UNITED STATES PATENT AND TRADEMARK OFFICE

Office Action Summary

The following title is suggested: **HAND-HELD INK-JET PRINTING DEVICE.**

FIG. 4

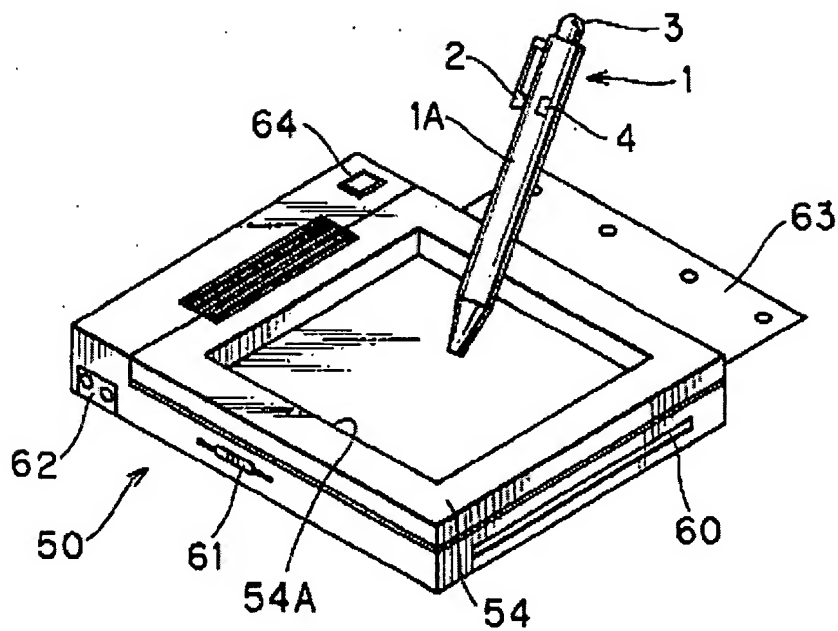
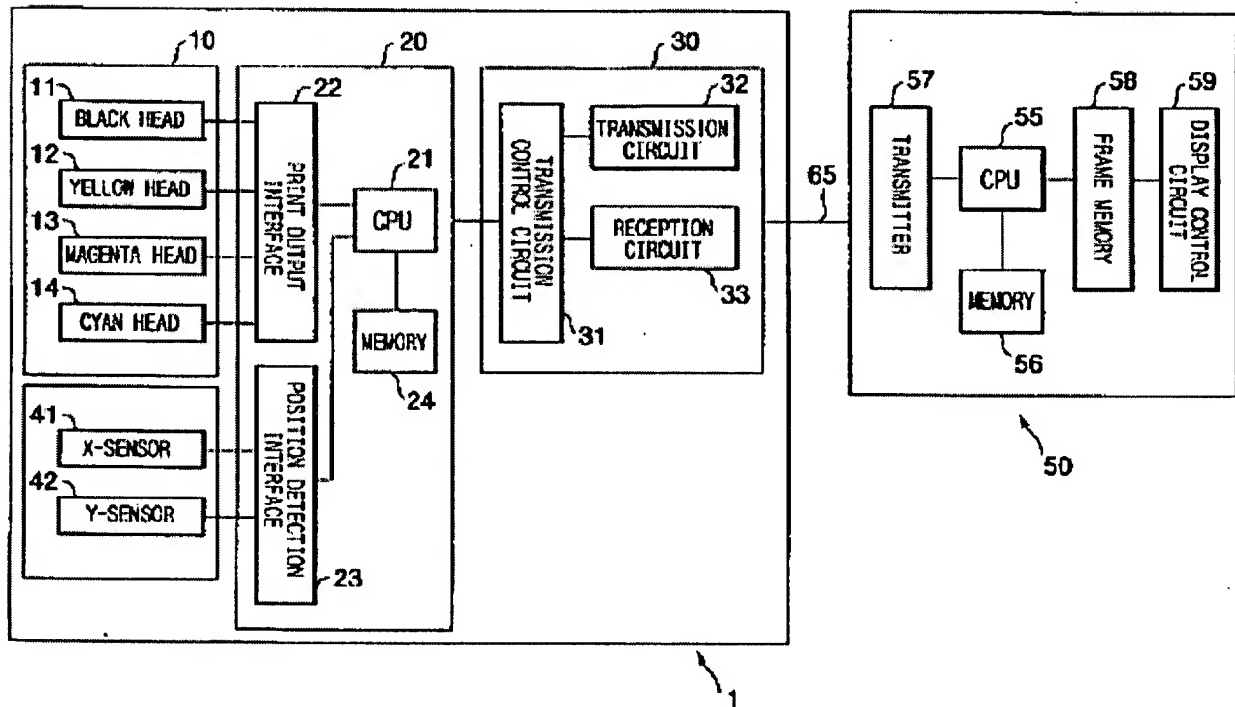
d. As related to independent **claim 1**, Kagayama et al. teach a sensor and print-head assembly comprised in a housing (Kagayama et al. – Figures 4 & 7, shown below), controlled by a processor (Kagayama – Figure 7, Reference #55, shown below) connected to at least one first electronic memory (Kagayama – Figure 7, Reference #56, shown below), comprising at least one sensor means (Kagayama – Figure 7, Reference #41 & #42, shown below), a print-head array (Kagayama – Figure 7, Reference #10, shown below), input means (Kagayama – Figure 4, Reference #3, #4 & #64, shown below), and means for keeping track of the assembly's and print-head's position on a print medium (Kagayama – Figure 7, Reference #41 & #42, shown below).

FIG. 7

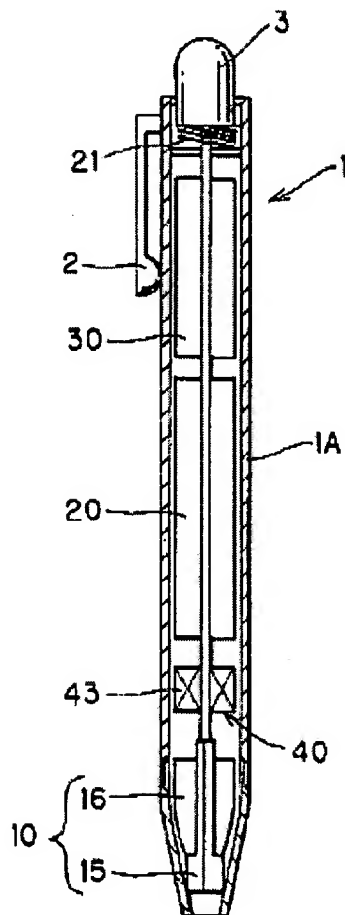
- e. Continuing with **claim 1**, Kagayama et al. teach the processor is provided a connection to a hardware control arrangement (Kagayama – Figure 4, Reference #4 & #64 and Figure 7, Reference #65, both shown previously & Detailed Description, Column 3, Lines 29-32). Additionally, Kagayama et al. teach the arrangement comprising a programmable logic means (Kagayama – Figure 7, Reference #21, shown previously), connected to at least one second electronic memory (Kagayama – Figure 7, Reference #24, shown previously), and having input means for receiving measurement signals from said at least one sensor (Kagayama – Figure 7, Reference #23, shown previously).
- f. As related to dependent **claim 2**, Kagayama et al. teach the print-head is of the ink-jet type with spray nozzles (Kagayama et al. – Detailed Description, Column 3, Lines 36-40 and Figure 1(b), Reference # 10, shown below).
